Is the North Spur dam safe?

I have written several articles about my concerns regarding the safety of the North Spur dam, concluding in my last article that the dam was not safe. However, on undertaking a more detailed analysis of the NALCOR reports, I have changed my mind, and now believe the dam to be safe.

Figure 1.

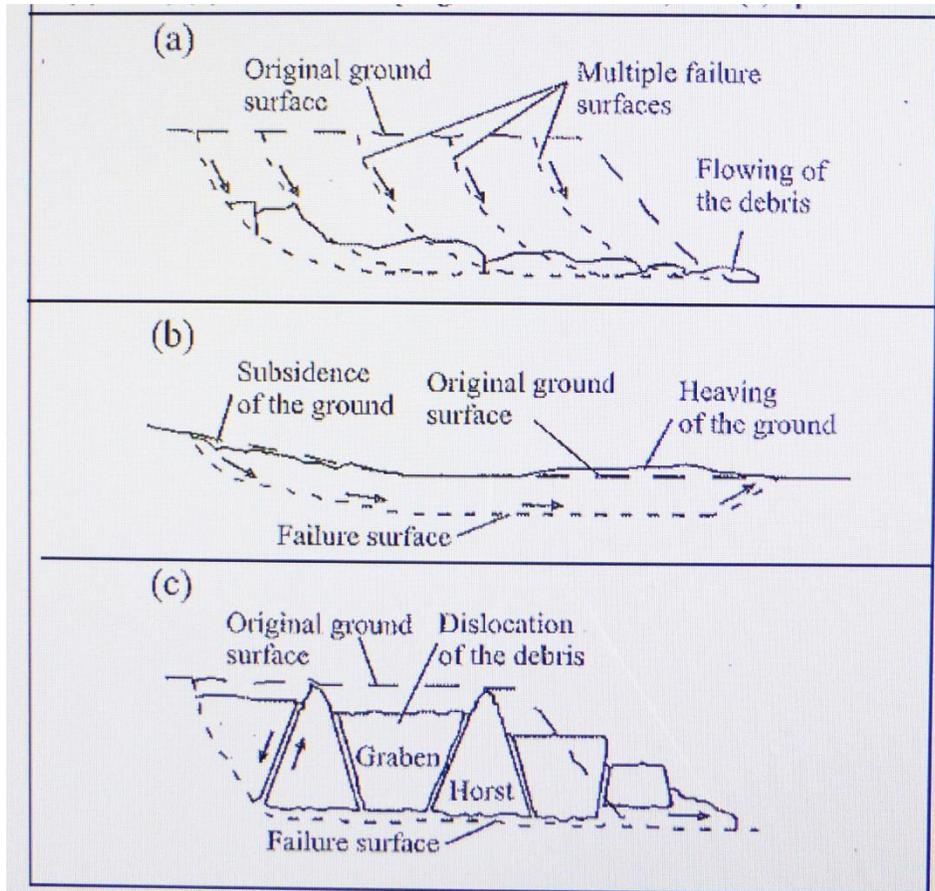
My initial concerns centered on the report by Dr. Bernander identifying many progressive landslides in the river valley near the North Spur. What is a progressive landslide – it is a landslide which can occur in soft (quick) clays where the land mass slides downhill on failure of a weak zone below the surface, as shown in Figure 1, sections (b) and (c).

As defined by Dr. A. Locat *“the concept of progressive failure may explain translational progressive landslides and spreads — large landslides occurring in sensitive clays. During progressive failure, the strain-softening behaviour of the soil causes unstable forces to propagate a failure surface further in the slope. Translational progressive landslides generally take place in long, gently inclined slopes. Instability in a steeper upslope area is followed by redistribution of stress, which increases earth pressure further downslope.”* Source – Abstract to paper referenced in Figure 1.

Figure 2.

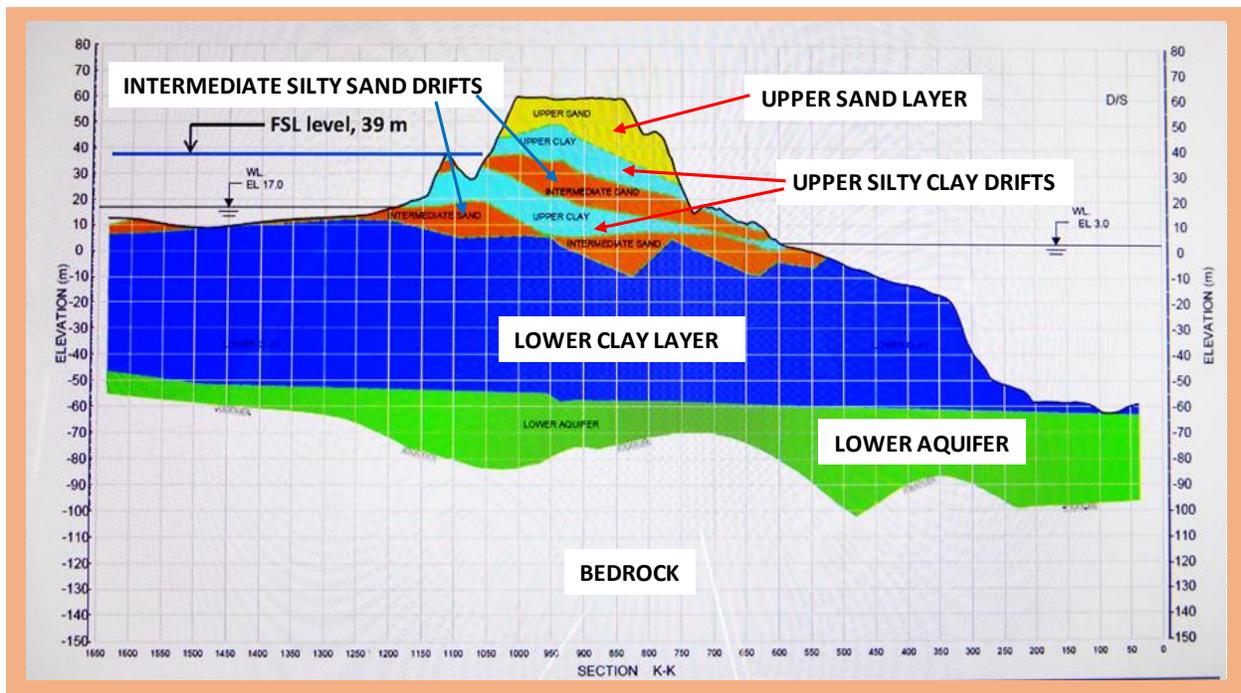
A few tests on soil samples retrieved from the two "Upper Silty Clay Drifts" – see Figure 2 have indicated the presence of soft clays. The sensitivity ranged from 1 to 36 in 43 samples, with an average of 10. Source NALCOR 2016 report. Page 91. This is not soft enough to be considered "quick", according to Carlton U. Moreover, during the excavation work required to re-shape the North Spur, there were no instances of liquefaction nor small landslides. All clay removed by shovels and dumped into trucks remained in clumps. This indicates that the pockets of quick clay (if any) were far too small to cause landslides.

Dr. Bernander also reviewed the data available on the lower clay layer (See figure 2). This layer provides the foundation for all the soils above water level in the North Spur. Again, Dr, Bernander concludes *"... that layers with high sensitivity also occur in the Lower Clay formation — a fact that allows the possibility of developing a progressive failure"*. Source Bernander 2016 report, page 8.

On the other hand, NALCOR data from tests on soil samples retrieved from the lower clay layer do not indicate the presence of soft clays. Instead, the clay is characterised as *"stiff to very stiff"*. All tests on this deposit indicate sensitivities well below 30, hence no quick clay. Quote - *"sensitivity values obtained for this unit vary between 2 and 11, with an average of 4"*. Source – NALCOR 2016 report, page 98.
